1411 South Potomac
Aurora, CO 80012
Suite 210

Advanced Urology Expansion

28 Sep 2020 Tenant Revisions & Approval (Revised by MW) and Construction

City of Aurora Building Division
Reviewed for Code Compliance
Approved as Noted: **John Lichtner**
Date: **Oct 06, 2020**
2015 INTERNATIONAL CODES & 2020 NEC

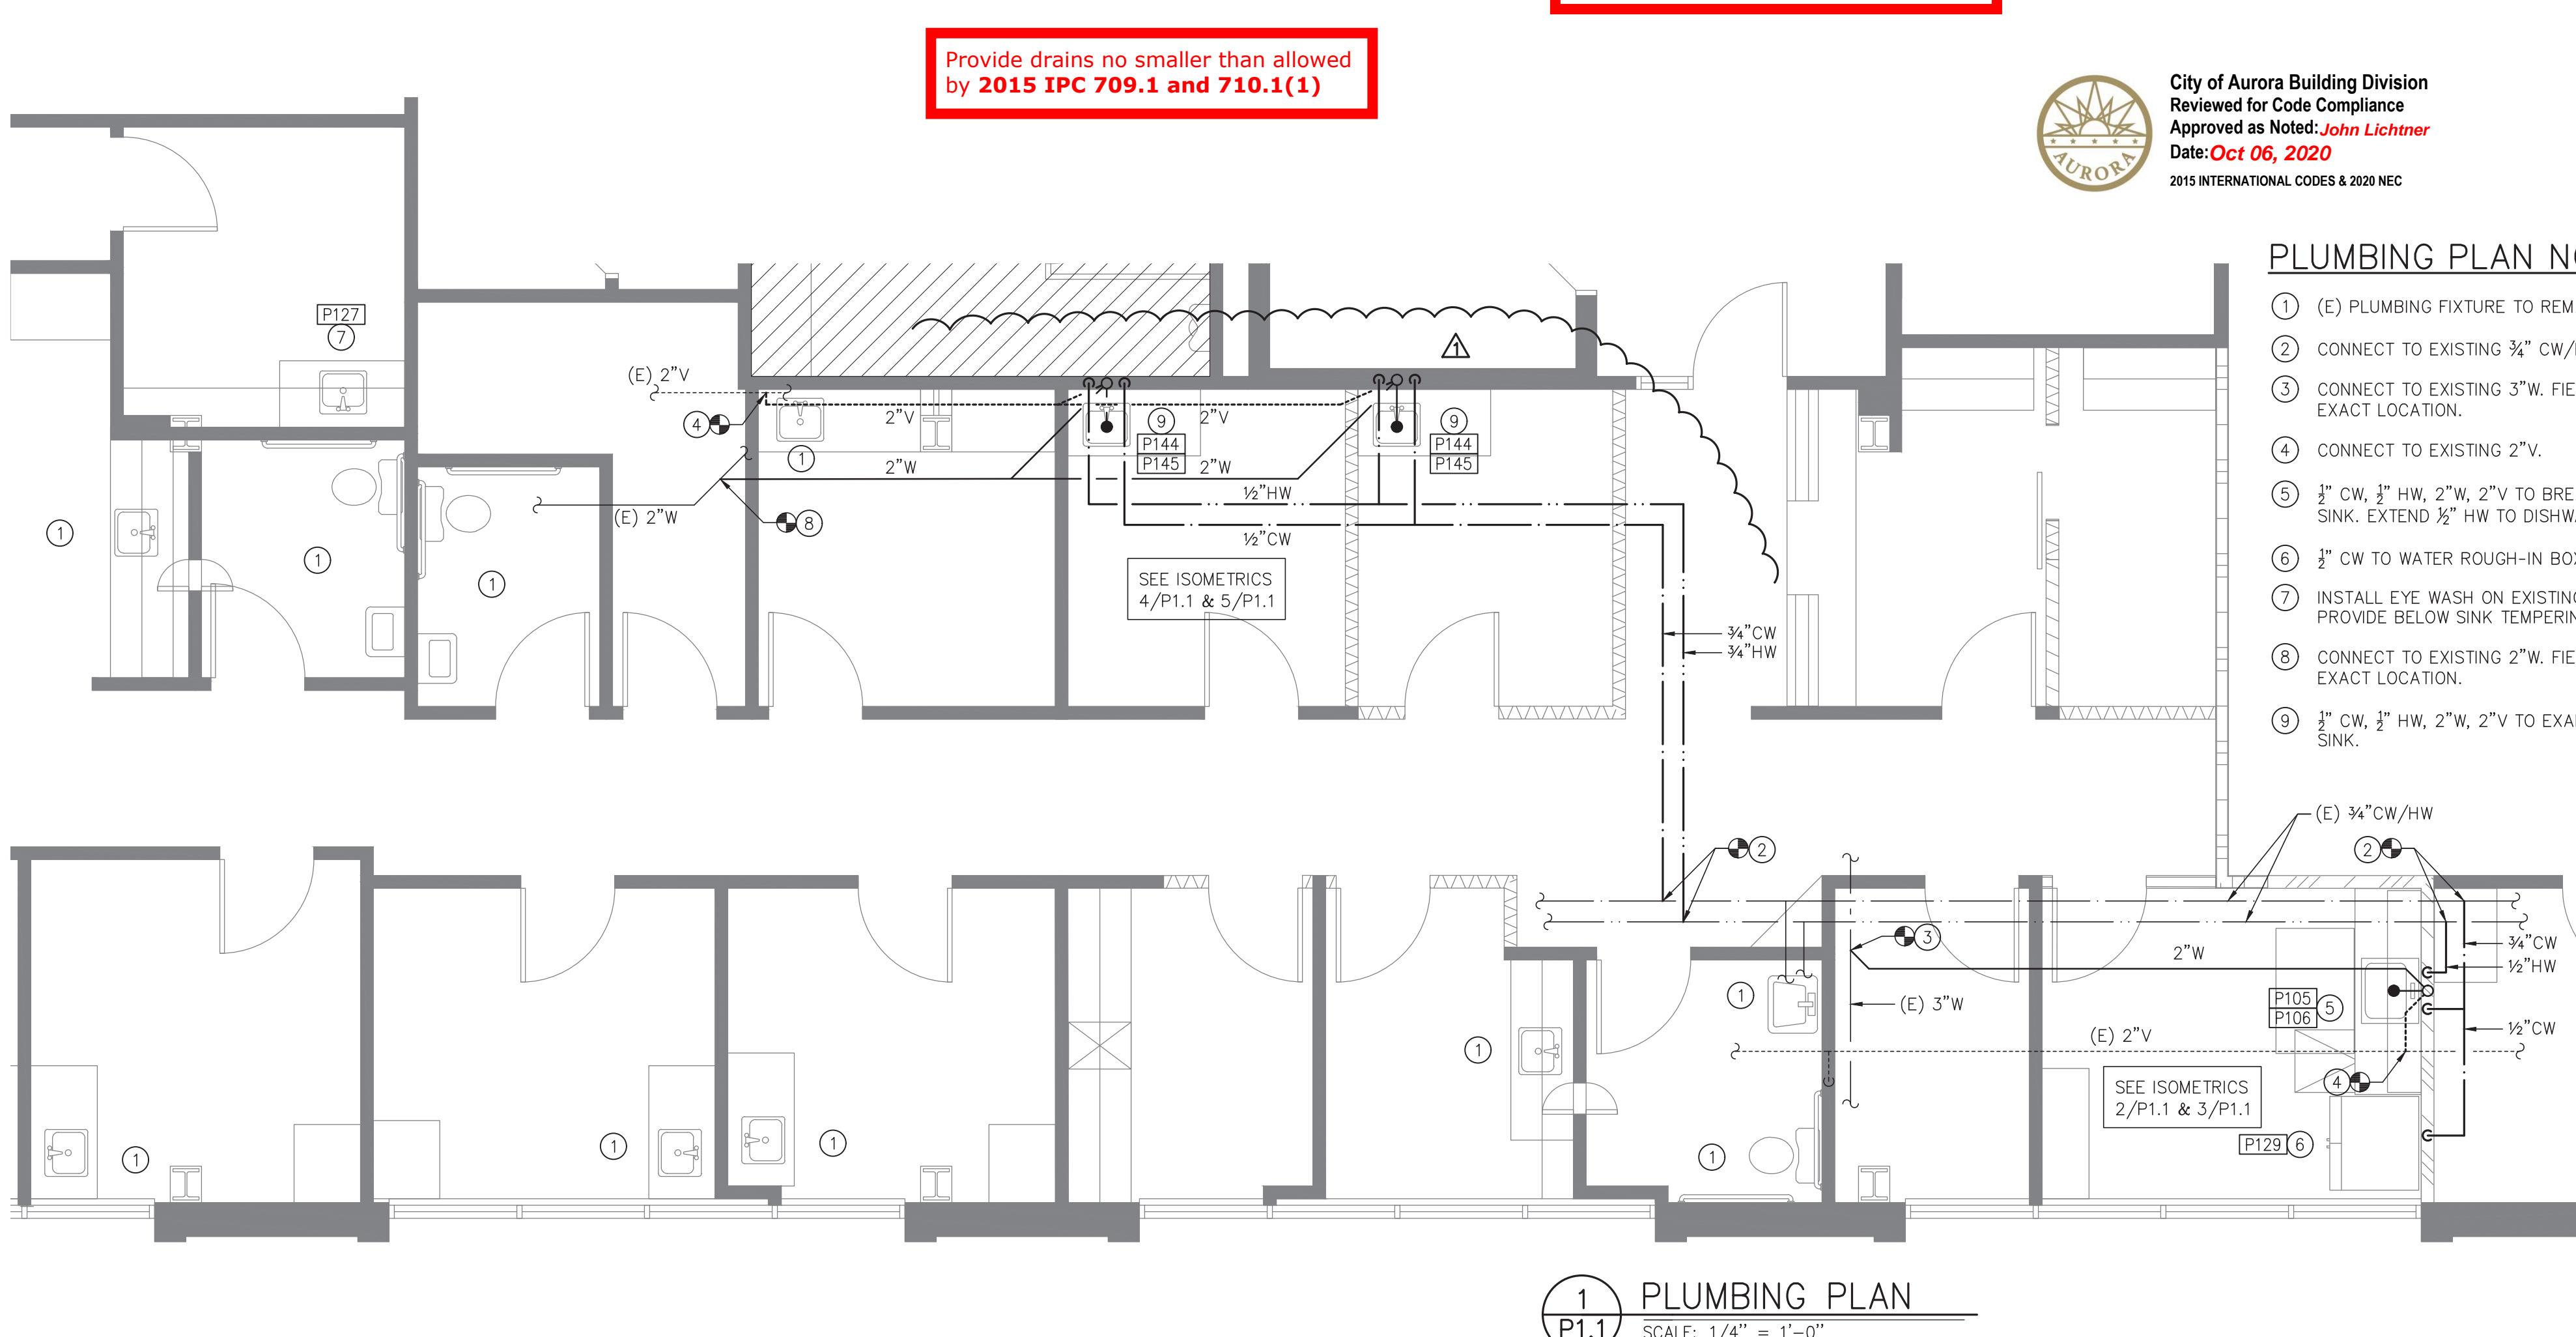
Provide drains no smaller than allowed
by **2015 IPC 709.1 and 710.1(1)**

Sheet Contents Power Plan
Project Team AW/R
Project Number 19362
Sheet Mark
E2.0

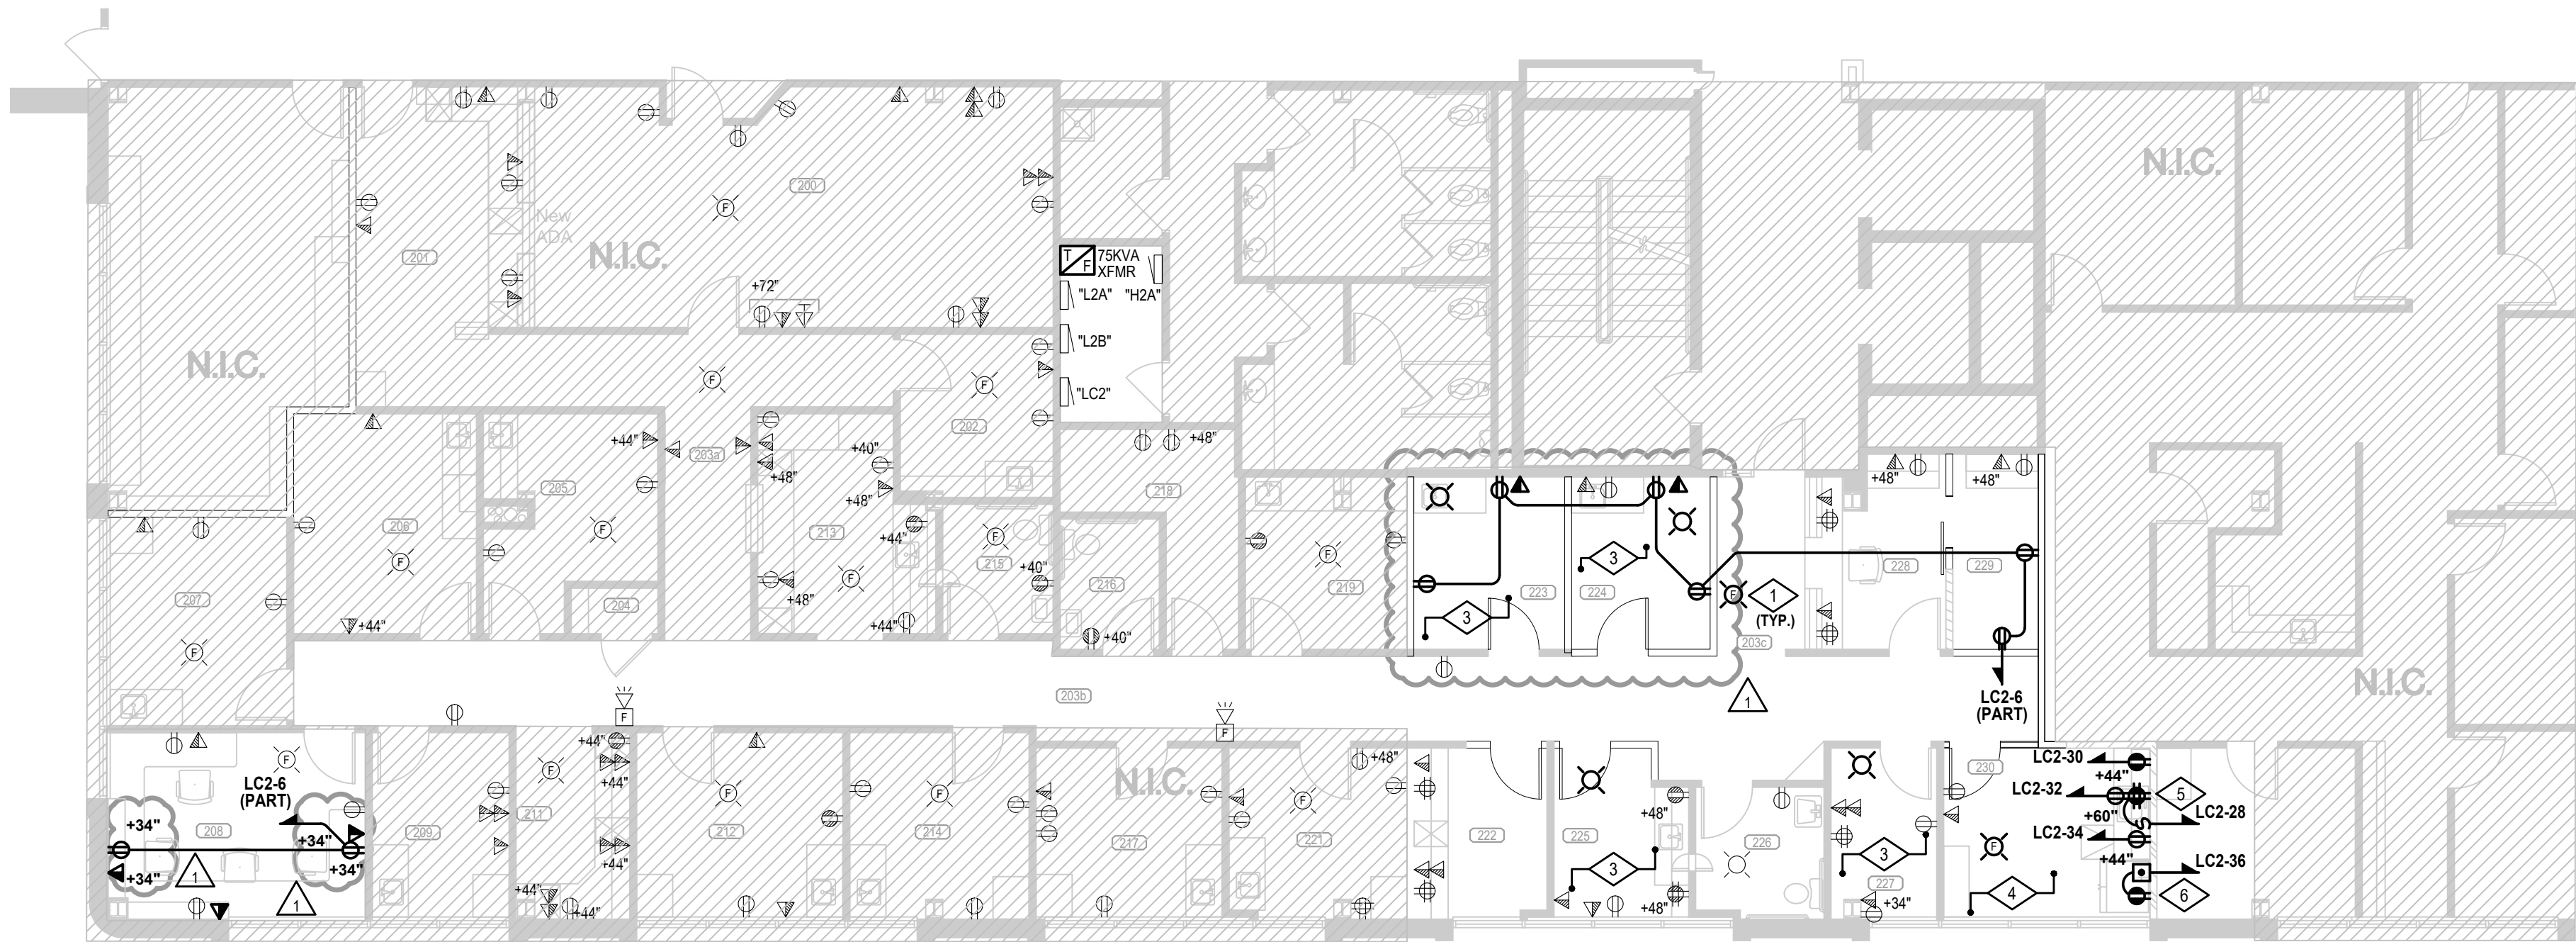
GFCI Protection required
within 6 feet of sinks - 2020
NEC 210.8(B)

Only highlighted or clouded
revisions are approved on this
review. All previous comments
apply.
